**Date of Issue:** December 2014

**Affected Publication:** API Specification 6A, *Specification for Wellhead and Christmas Tree Equipment*, Twentieth Edition, October 2010

## **ERRATA 7**

Page 198, **Table 87** (continued):

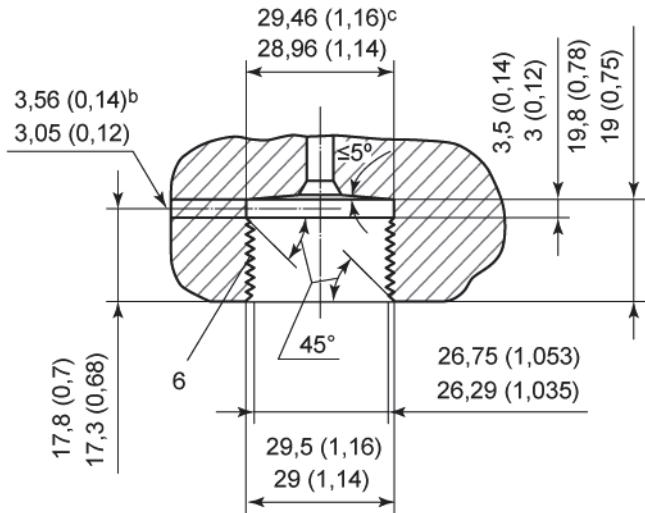
The first two columns, for **13,8 MPa**, **20,7 MPa**, and **34,5 MPa**, should read as follows:

Nominal size and bore	
Vertical $B_V$ +0,8 0	Outlet $B_0$ +0,8 0
<b>13,8 MPa</b>	
52	52
65	52
65	65
<b>79</b>	52
<b>79</b>	65
<b>79</b>	<b>79</b>
103	52
103	65
103	<b>79</b>
103	103
<b>20,7 MPa</b>	
<b>79</b>	52
<b>79</b>	65
<b>79</b>	<b>79</b>
103	52
103	65
103	<b>79</b>
103	103
<b>34,5 MPa</b>	
52	52
65	52
65	65
<b>79</b>	52
<b>79</b>	65
<b>79</b>	<b>79</b>
103	52
103	65
103	<b>79</b>
103	103
130	52
130	65
130	<b>79</b>
130	103
130	130
